# Illustrated Parts List - IPL Update

**281XP**

Removal of Plug 503 27 90-04.  
Reason: The plug does not fill any function anymore.

## 1. Crankcase

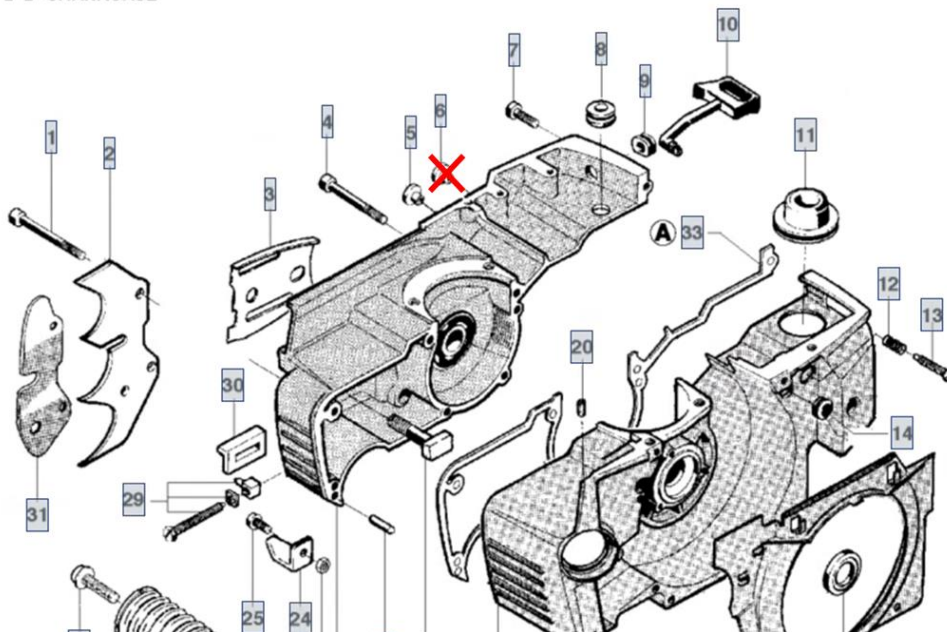
Remove plug 503 27 90-04 (pos. 6).
